TECHNICAL BULLETIN

IMPROPER OPERATION – IMMEDIATE ACTION REQUIRED

- SUBJECT:** CAR DOOR LIMIT WIRING (BARREL PROXIMITY SENSORS)
- EQUIPMENT:** PEELLE CAR DOORS WITH PLC (2742) CONTROLLER SERIES (BARREL PROXIMITY SENSORS WITH PLUG-IN CABLES ONLY)

**PLUG IN TYPE
(ACTION REQUIRED)**

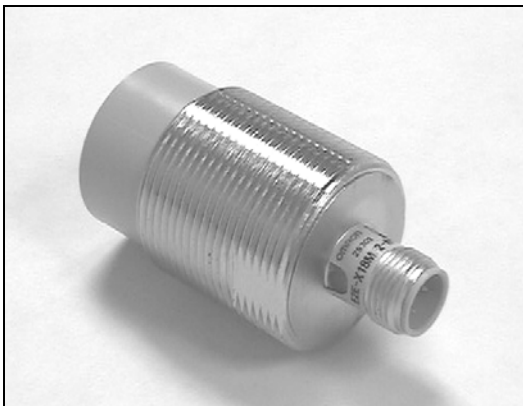
- DESCRIPTION:** PEELLE HAS DISCOVERED A WIRING DISCREPANCY AFTER CHANGING FROM A HARD WIRED PROXIMITY SENSOR TO A PLUG-IN PROXIMITY SENSOR. THE CABLE USED FOR PLUGGING INTO THE PROXIMITY SENSOR HAS BEEN PREWIRED INCORRECTLY TO THE PEELLE KNOCK OUT BOXES, WHICH ARE MOUNTED TO THE GATE SPREADER. THIS RESULTS IN LOW SPEED CAR DOOR TRAVEL AND MOTOR SHUTOFF BEFORE FULL OPEN OR FULL CLOSE OF THE CAR DOOR.
*WIRING FOR JOBS SHIPPED AFTER 8/9/2002 HAS BEEN CORRECTED.

- ACTION:** CHECK PEELLE CAR GATE BARREL PROXIMITY SENSORS. IF THE SENSORS ARE PLUG-IN TYPE, OPEN SPREADER KNOCK OUT BOXES WHERE SENSORS ARE WIRED (ONE ON COUNTERWEIGHT SIDE AND ONE ON RETIRING CAM SIDE). LOCATE SENSOR PLUG-IN CABLE AND DISCONNECT BLACK WIRE FROM "GOL" AND "GCL" TERMINAL BLOCKS IN KNOCK OUT BOXES. STRIP PLUG-IN CABLE INSULATION TO EXPOSE WHITE WIRE. CONNECT WHITE WIRE TO "GOL" AND "GCL" TERMINAL BLOCKS. CLOSE KNOCK OUT BOXES.
